SUBJECT: Recommendation report for official plan and zoning by-law amendments for 1085 Clearview Ave., 1082, 1086 and 1090 St. Matthew's Ave.

Report Number: PB-31-19

File Numbers: 520-02/19 and 505-01/19

Date to Committee: July 9, 2019

North Elevation

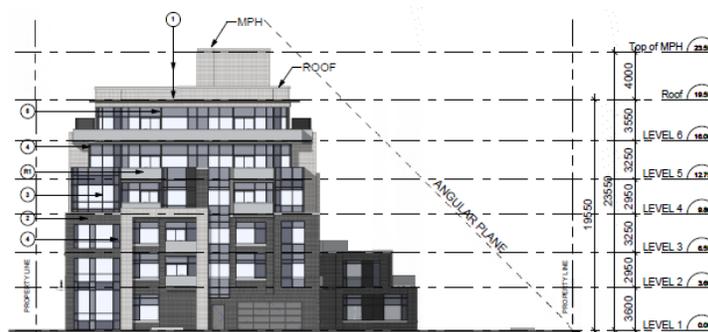
The building addresses the low-rise residential context on the east side by reducing the building height to 2-storeys. However, the building height on the west side of the building does not transition to the low-rise residential uses on Clearview Ave. as terracing is only provided from the 5th and 6th storey. The overall building length of 113 metres is not representative of, or contextually appropriate for, the scale of the surrounding residential neighbourhood. A design that visually separates the building into two distinct buildings over the length of the city block would provide a building scale which could better relate to the context on either side street and break up the overall massing.

The east side of the building has been treated to relate to the 2-storey building heights along St. Matthew's Ave. A similar treatment has not been applied to the west side of the building along Clearview Ave. The majority of the rear of the building has been setback 21.7 metres from the property line abutting the R2.1 zone to the south and the sixth floor is setback 24 metres. The building fits within the 45-angular plane, however the minor building wall stepback on the sixth floor along the length of the building does not adequately reduce the overall building massing perception from the neighbouring residential properties. Building wall stepbacks combined with building separation would assist in achieving the intent of this guideline.
